**Facility-Wide GW
Monitoring Plan
(FWGWMP)**

**RE: DISAPPROVAL
2011 FACILITY-WIDE GROUNDWATER MONITORING REPORT
AND
2012 FACILITY-WIDE GROUNDWATER MONITORING REPORT
WESTERN REFINING, SOUTHWEST INC., GALLUP REFINERY
EPA ID# NM000333211
WRG-12-003
WRG-13-003**

Re: Disapproval – Facility Wide Ground Water Monitoring Work Plan, 2011
Updates
Western Refining Company Southwest Inc., Gallup Refinery
EPA ID #NMD000333211
HWB-WRG-12-002

**Facility-Wide Ground Water Monitoring Work Plan
Gallup Refinery – 2011 Updates**

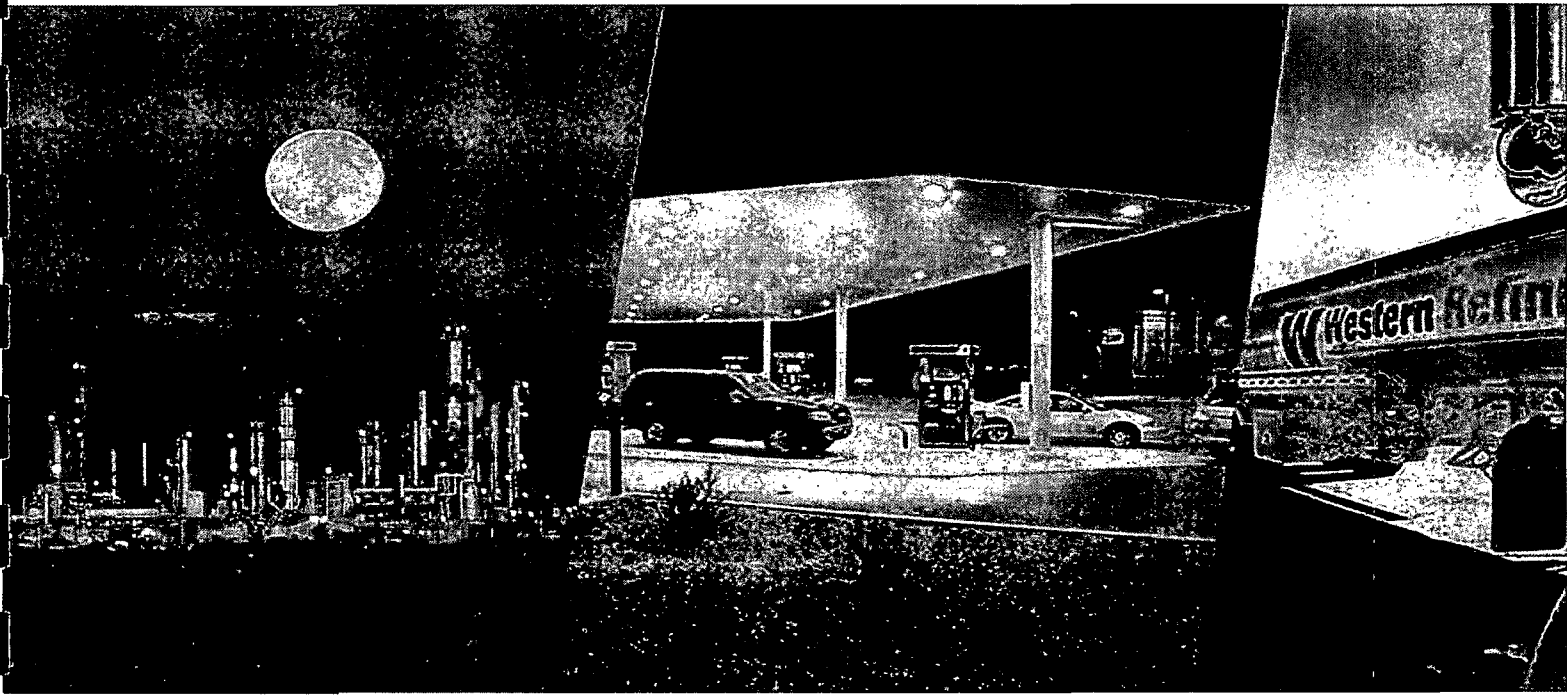
There are several issues regarding the figures included in the Work Plan. Figure 3, Figure 5 and Figure 5b are difficult to read. Remove the hatching over the SWMUs in Figure 3. Increase the font size or do not bold the ground water monitoring well labels so that they are legible. On Figure 5 remove the closed (abandoned) wells. The NAPIS wells are mislabeled as KA-wells on all three figures; re-label them appropriately. Ensure that the figures include all of the ground water monitoring and recovery wells. Use the same base map showing all ground water and recovery wells for all of the figures. On Figures 5 and 5b, include the ground water elevations along with the ground water monitoring well designation labels so that the elevations and ground water contours can be verified. Report the dates that the ground water data were collected in the map legend. Revise the figures as needed.

Response: *All the figures have been revised as requested. Figure 5b has been relabeled as Figure 6.*
